Subject: Duke Power Company LLC d/b/a Duke Energy  
Carolinas, LLC (Duke)  
Catawba Nuclear Station, Unit 1  
Docket Number 50-413  
Request for Relief Number 05-CN-004  
Reply to NRC Request for Additional Information  
(TAC Number MC8337)

REPLY TO NRC REQUEST FOR ADDITIONAL INFORMATION

Notes for Clarification on Catawba, Unit 1  
Request for Relief 05-CN-004, Revision 0  
TAC MC8337

SHEET  
TITLE OUTLET SAFE END DETECTION AND SIZING

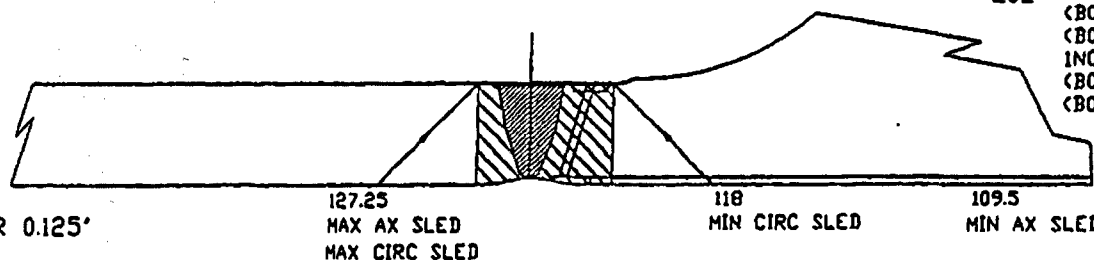
- 2) Request for Relief 05-CN-004, Item 7 covers dissimilar metal welds on the RPV primary outlet nozzle-to-safe end (Examination Category B-F, Items B5.10 and B5.130, as listed by the licensee).
  - a) It is not clear from the sketches provided by the licensee that weld 1NC23-01 is a dissimilar metal weld. This weld appears to be a wrought stainless steel (safe end) to stainless steel (piping) weld.

Please confirm this configuration. If this is indeed a safe end to pipe weld, this should be Examination Category B-J, Item B9.11 (see discussion below).

- c) The licensee's submittal (Adobe PDF file) is missing Page 3 of 3 in Attachment G, which should help explain the coverage for these welds. Please submit this page.

Note that there are two (2) welds within close proximity to each other at this and similar Reactor Vessel Loop locations. There is a B-F weld of wrought stainless steel safe-end to cast stainless steel weld and a carbon steel vessel nozzle to wrought stainless steel safe-end.

During the Catawba 1st Interval ISI Plan development process, the decision was made to take a conservative approach in evaluating the configuration of the Reactor Vessel Nozzle SS Safe End to Centrifugally Cast SS Piping Welds as dissimilar metal welds. This same conservative approach was applied to the 2nd Interval during ISI Plan development. Consequently, Duke included these welds in Examination Category B-F, Pressure Retaining Dissimilar Metal Welds as part of Item Number B5.130, Dissimilar Metal Piping Butt Welds NPS 4 or Larger, which required a surface and a volumetric examination once per interval per ASME Section XI, 1989 Code, no addenda. Had Duke chosen to consider this configuration to be similar metal, these welds would have been included in the total population of Examination Category B-J, Pressure Retaining Welds In Piping, which only requires a 25% sample of the total number of circumferential butt welds.

The 1989 ASME Section XI, no addenda was the Code of record for the 2nd Ten Year Inspection Interval for Catawba Unit 1. Examination Category B-F, Table IWB-2500-1, Item Number B5.130 pertains to Piping NPS 4 or Larger Dissimilar Metal Butt Welds. Weld ID. 1NC23-01 was considered (as described in response to Question 2(a) above) as a dissimilar metal weld. This weld is a wrought stainless steel (safe end) to stainless steel (piping) weld, and was included in the ISI Plan as a B5.130 Item Number.

The missing page is provided herein.
